Major Energy Users Inc.

19 February 2013

Submission re: Draft Decision on Murraylink application for a revenue reset

Figure 3.2 Murraylink's actual/estimated and proposed opex by cost category, 2008–23 (\$ million, 2012-13)

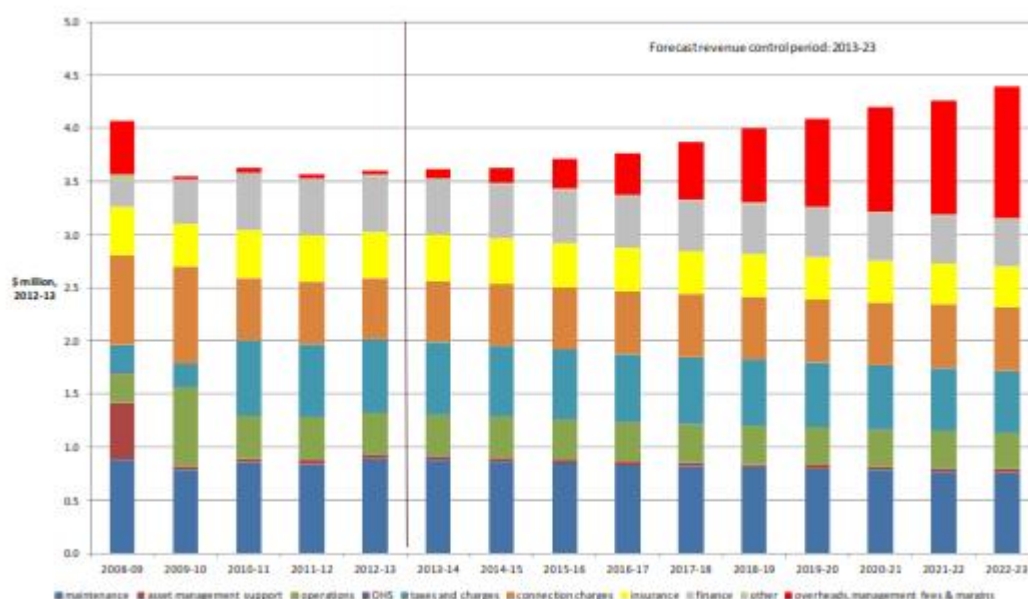
The first and obvious aspect is that Murraylink was including ever increasing amounts of “overheads, management fees and margins” (shown in red). This is despite the fact that essentially the service Murraylink provides does not change at all over the forecast 10 year period. This issue of overhead, management fees and margin was in part raised by the MEU in relation to the Murraylink application but has been frequently raised by the MEU in relation to other regulatory reviews where the service provider out sources considerable amounts of work to related parties and not always on an arms-length basis. The MEU is pleased that the AER has addressed the issue of related party transactions in this case.

The second aspect of the AER graphical analysis is that direct elements of the opex costs show a distinct and consistent reduction over time. In fact, total opex less overheads, management fees and margin was forecast by Murraylink to reduce by at least 1% pa cumulatively over the 10 year period.
